AGENDA

ARCHITECTURAL REVIEW BOARD MEETING

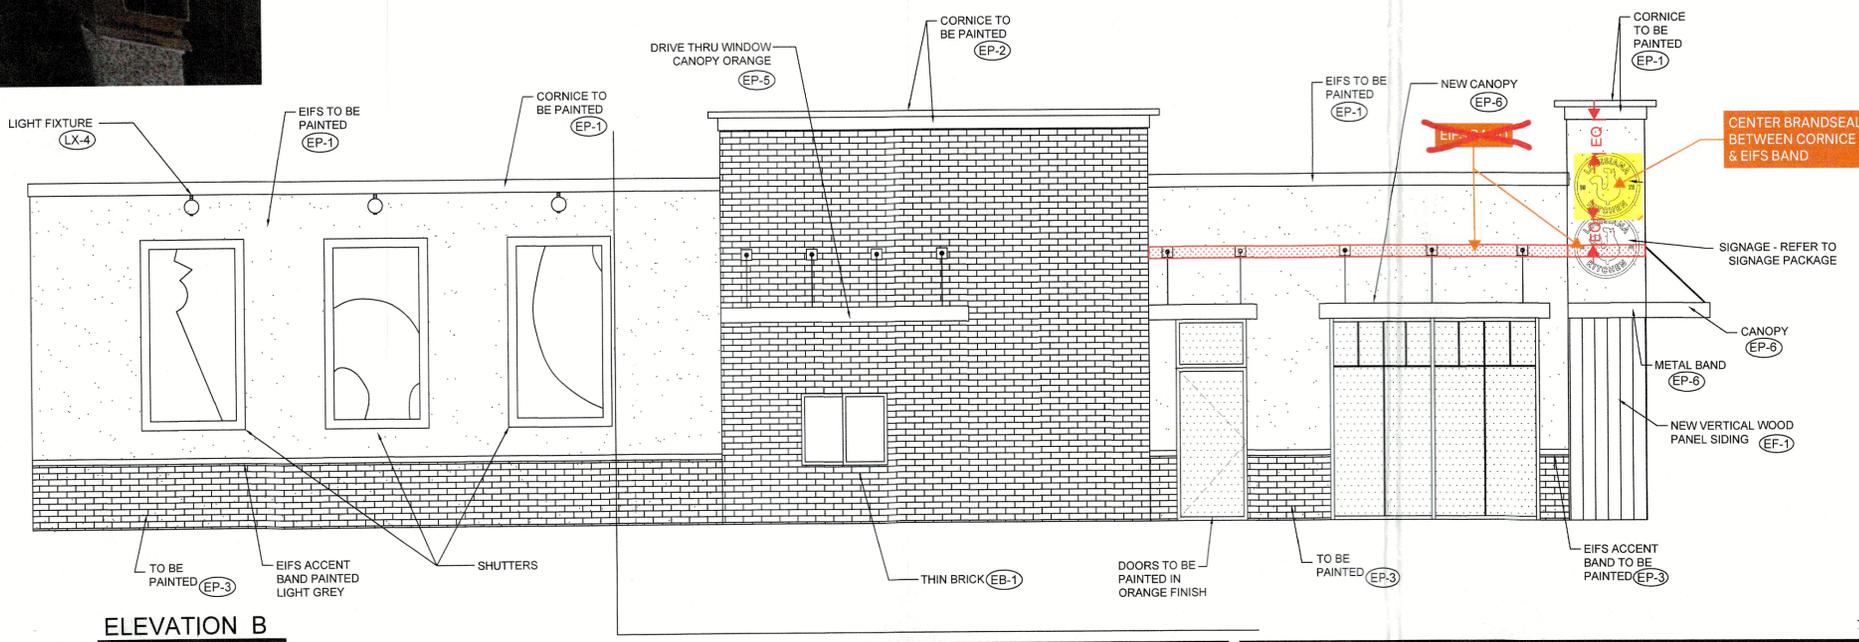
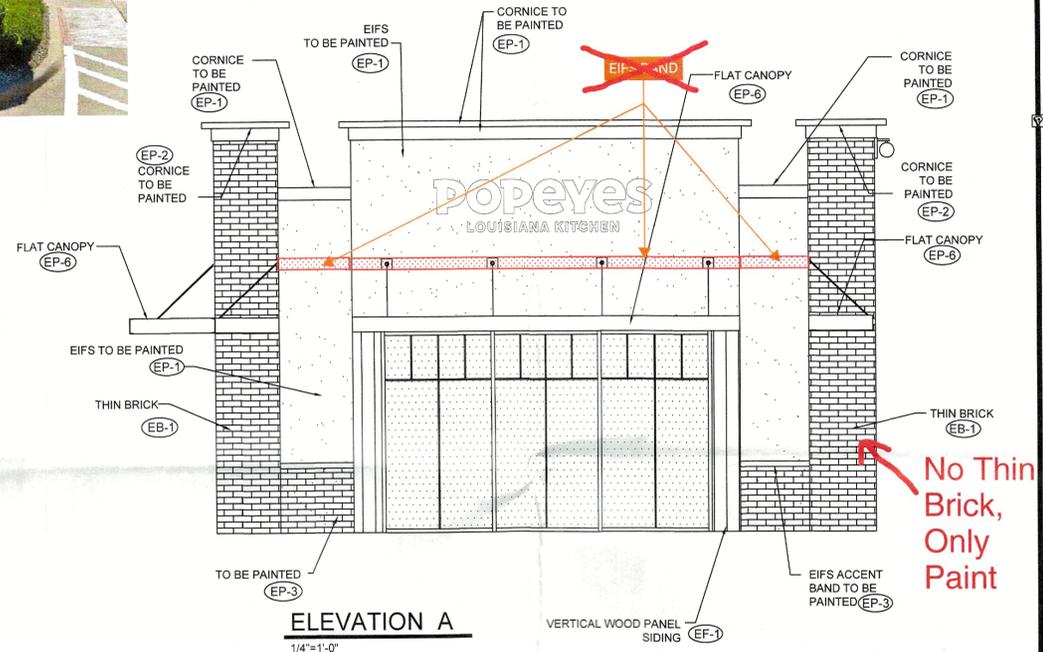
APPROVED AS NOTED

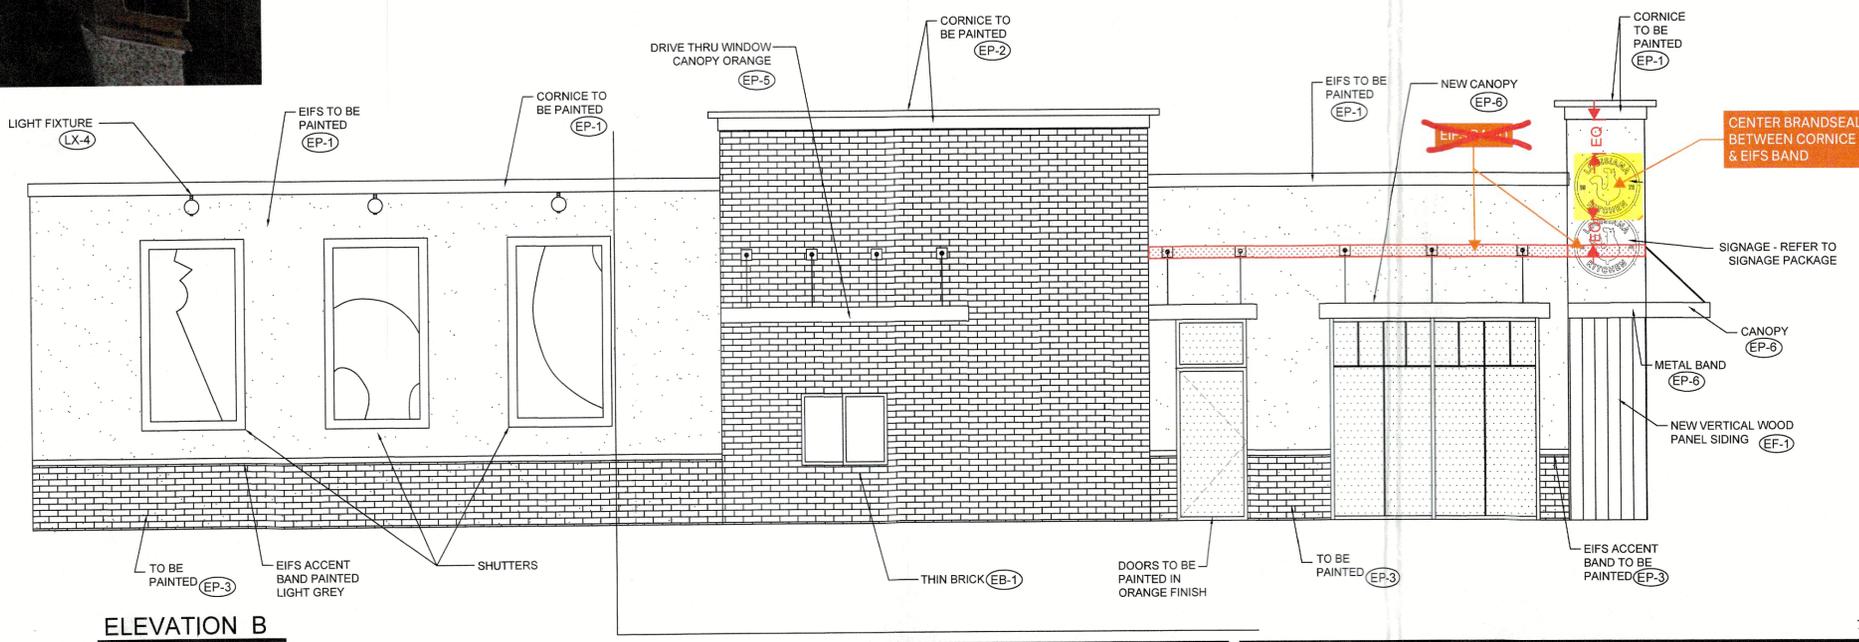
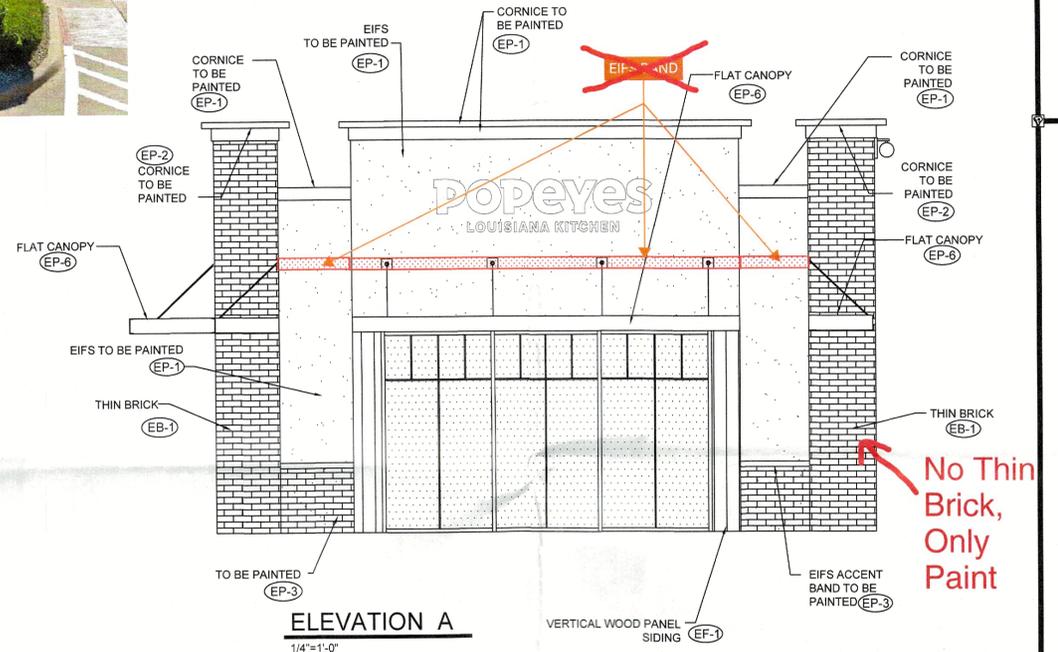
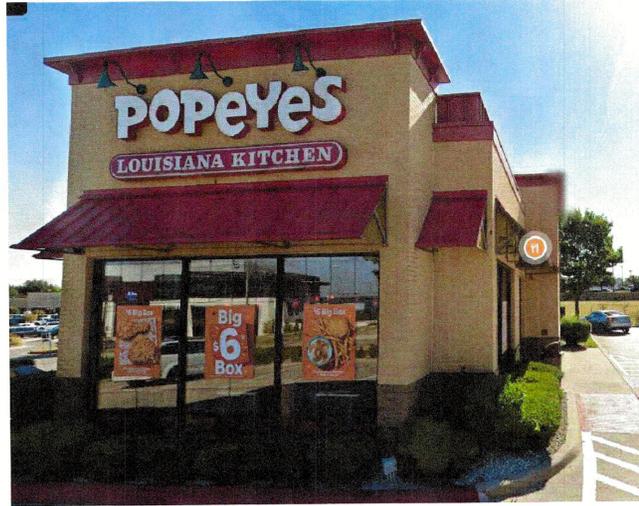
APPROVED AS NOTED
